# CITY OF ALBUQUERQUE

**RE: 8004 Shiprock Ct NW  
Grading & Drainage Plan  
Engineer's Stamp Date: 7/2/24  
Hydrology File: E10D129  
Case # HYDR-2025-00236**

ENGINEER'S SEAL	LOT 19 BLK 7 U 5 VC 8004 SHIPROCK CT NW	DRAWN BY DEM
DAVID SOULE NEW MEXICO REGISTERED PROFESSIONAL ENGINEER 14522	GRADING AND DRAINAGE PLAN	DATE 6-29-25
7/2/24	Rio Grande Engineering P.O. BOX 53924 ALBUQUERQUE, NM 87199 (505) 321-9099	8004 Shiprock Ct NW.dwg
DAVID SOULE P.E. #14522		SHEET # C1
		JOB #

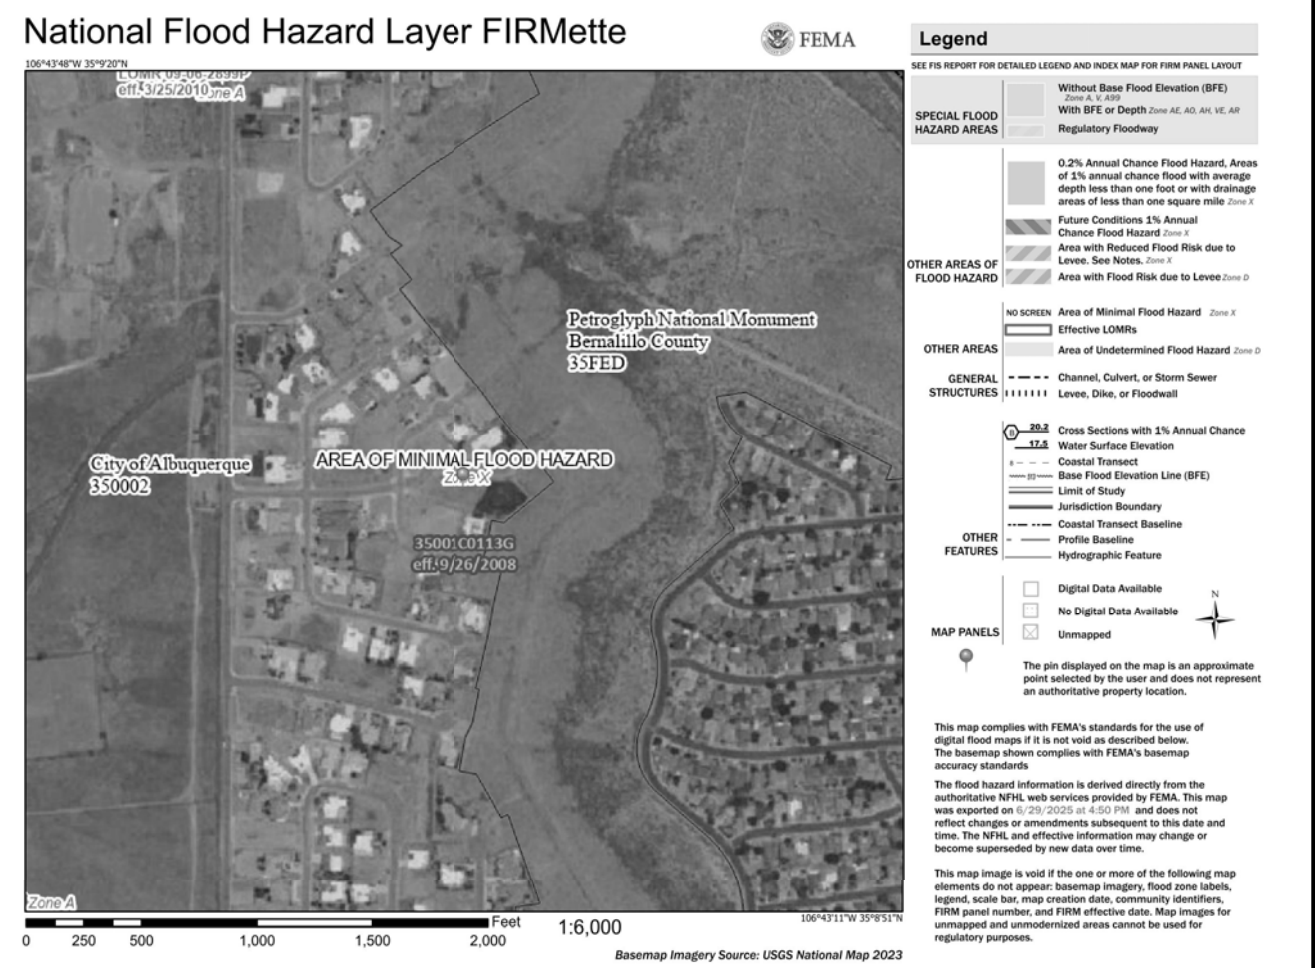
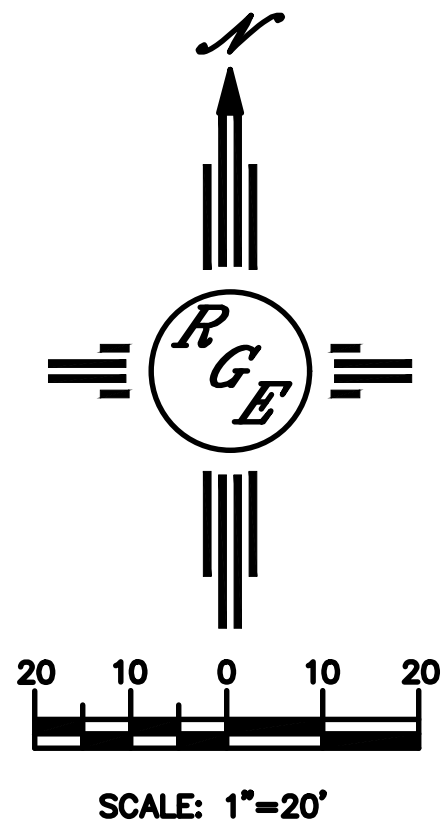
Based upon the information provided in your submittal received 07/02/2025, the Grading & Drainage Plan is approved for Building Permit and Grading Permit. Please attach a copy of this approved plan in the construction sets for Building Permit processing along with a copy of this letter.

1. Engineer's Certification, per the DPM Part 6-14 (F): *Engineer's Certification Checklist For Non-Subdivision* is required.
